ENLOE DLA COMMENT LETTERS

The National Park Service (NPS), Pacific West Region, offers the following comments in response to the Enloe Draft License Application (FERC #12569), dated November 7, 2007, submitted pursuant to 18 C.F.R. Section 16.8(b)(4).

Figure 1. Temperature data collected in a shallow area (left) and deep water habitat (right) with resulting trend lines when minimum, maximum, and mean values are used.

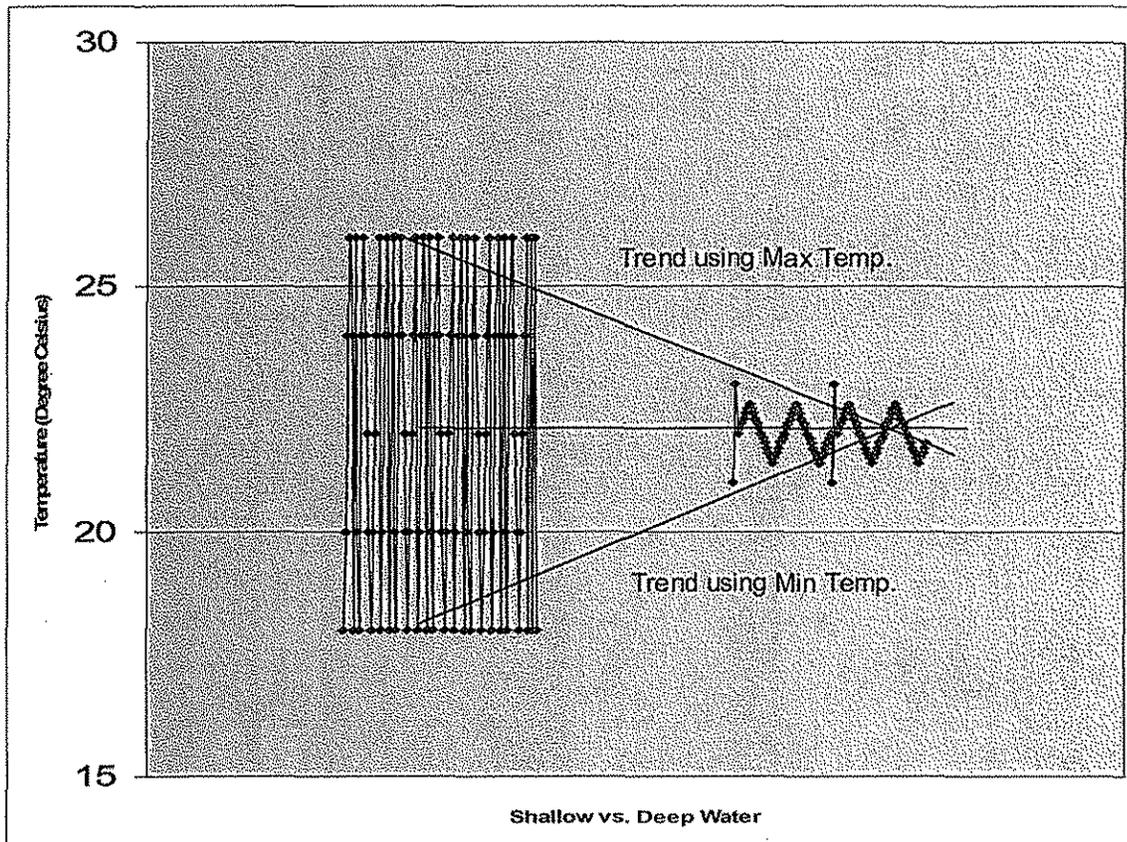
Water temperatures vary widely when data loggers are placed in shallow stream sections whereas those placed in deep water habitats have attenuated minimums and maximum temperatures (Figure 1). When determining differences between sites the use of maximum temperatures result in what would appear to be decreasing temperatures and use of minimum temperatures will result in what appears to be increasing temperatures. These results are the product of the study design and do not represent the true value that is unchanged as reflected by the mean temperature that focuses on the real temperature rather than the noise. Use of the 7day max temperatures in evaluating this project result in what appear to be decreasing temperatures which is misleading.

Water retained behind a dam will be exposed to increased solar radiation due to reduced shading from riparian vegetation, increased channel width, and reduced velocities, resulting in an increase in water temperature. The extent of this increase resulting from the existing project compared to historical is unknown and not addressed. In addition the amount of warming that could be attributed to the proposed pool raise is not predicted. Water temperatures (Figure E.2-1 of the draft application) downstream of the project area already exceed lethal levels for coldwater salmonids during the middle of the month of July and remain stressful from early July through mid-September. Therefore, any increase in water temperature would be considered detrimental to endangered summer steelhead that might attempt to rear in the Similkameen River from July through September and should be mitigated. Even temperature increases in the tenths of a degree should be mitigated for by supplementing coldwater inputs below the project from lake, or ground water to a level that would off set these increases 2 fold.

Figure 1: Spring and Summer Chinook Optimal Spawning Stock Escapement Goals based on Similkameen Watershed Area

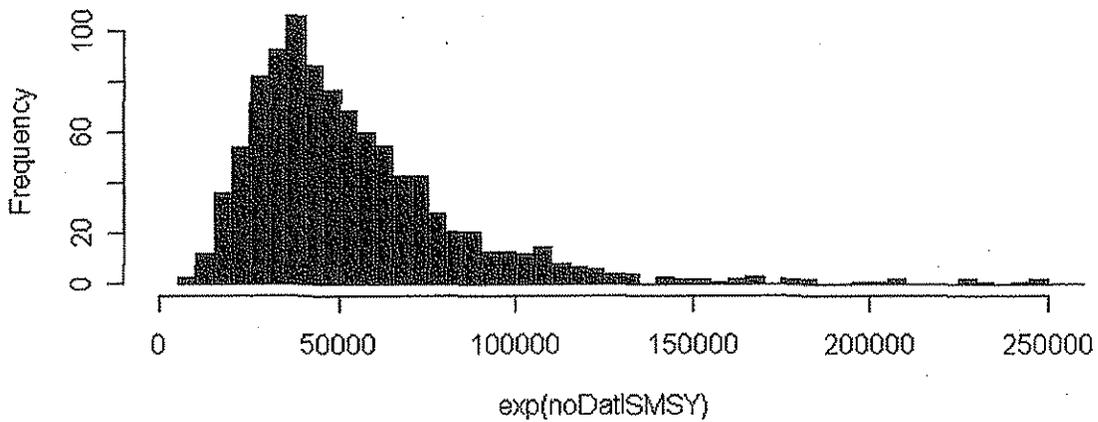
CRITFC engaged in a conference call with the applicant in the summer of 2007. At that time, and in all of these filings and junctures, CRITFC has consistently maintained that there is a need to provide fish passage studies as an integral part of the licensing process. The applicant has responded to this position in the DLA by stating that there is "regional consensus" not to provide fish passage, and the applicant has refused to include fish passage studies in the DLA.

Obviously there is no regional consensus not to provide fish passage at Enloe Dam. The CRITFC treaty tribes continue to support examination of fish passage over Enloe Dam.² Enloe Dam continues to block hundreds of miles of critical habitat for steelhead, summer chinook, coho, sockeye and likely Pacific lamprey, both in the U.S. and British Columbia. These fish stocks represent living cultural and treaty trust resources to which CRITFC's member tribes depend and are duty bound to protect and restore.
